**CITY OF TEMPE
DEVELOPMENT REVIEW COMMISSION**

**Meeting Date: 11/13/2012
Agenda Item: 4**

ACTION: Request for a Planned Area Development Overlay and Development Plan Review consisting of replacing the existing restaurant/drive-thru with a new 4,027 sf. restaurant/drive-thru building with 1,300 sf. of outdoor dining for CHICK-FIL-A (PL120217), located at 25 West University Drive. The applicant is Kerr Project Services Inc.

BACKGROUND INFORMATION: CHICK-FIL-A (PL120217) The applicant held a neighborhood meeting on October 25, 2012. This request would demolish the existing Burger King building and construct a new restaurant drive-through. The request includes the following:

Sheet
A-2.2

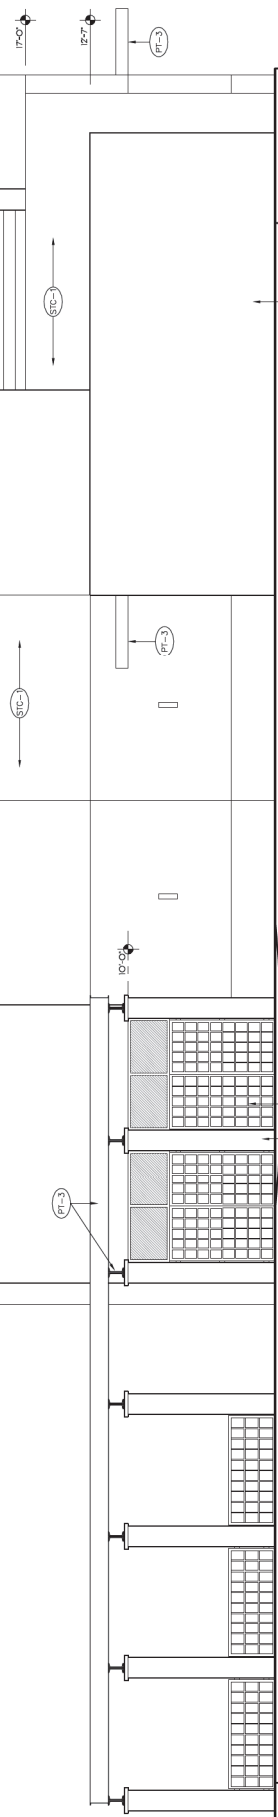
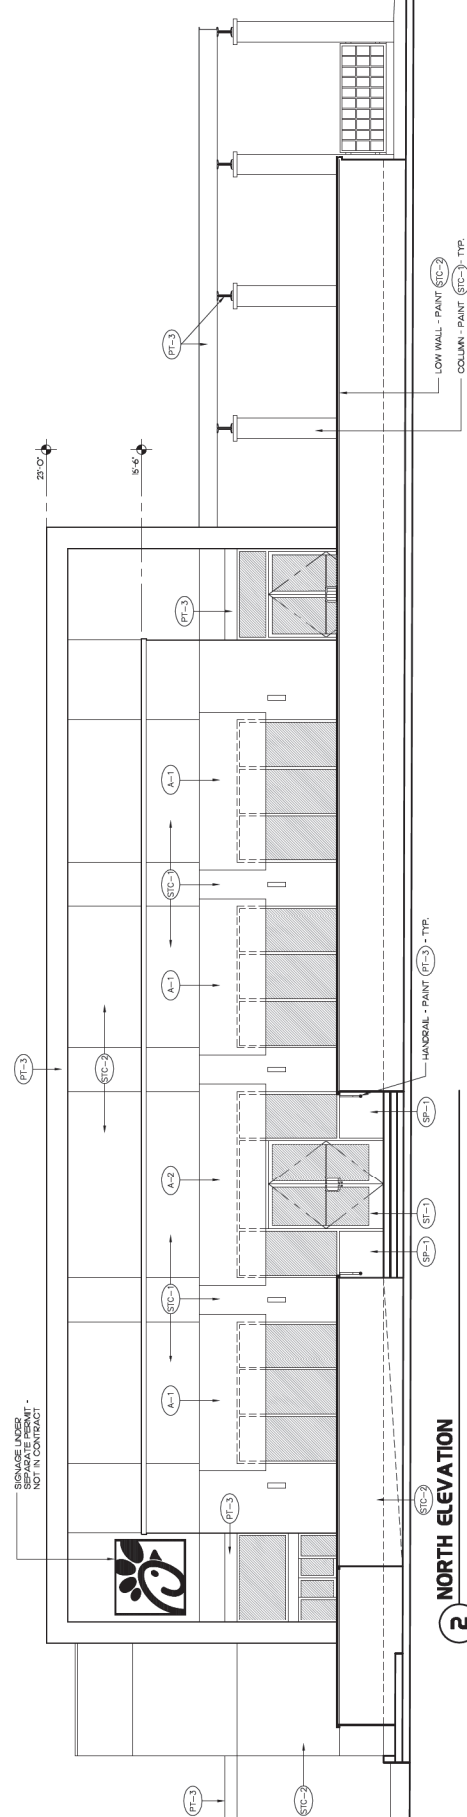
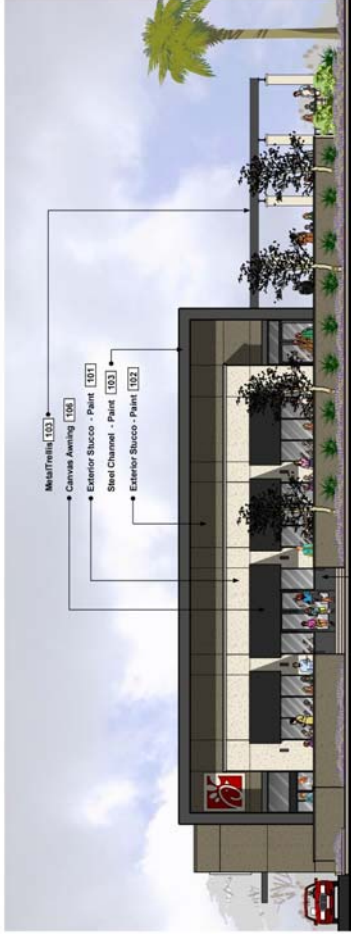
17. The patio walls facing Maple Avenue and University Drive shall be modified, providing open surveillance from the street, utilizing a similar design from other metal railings along the patio or a modified wrought iron fence.

18. Provide secure roof access from the interior of the building. Do not expose roof access to public view.
19. Conceal roof drainage system within the interior of the building.

20. Incorporate lighting, address signs, and incidental equipment attachments (alarm klaxons, security cameras, etc.) where exposed into the design of the building elevations. Exposed conduit, piping, or related materials is not permitted.
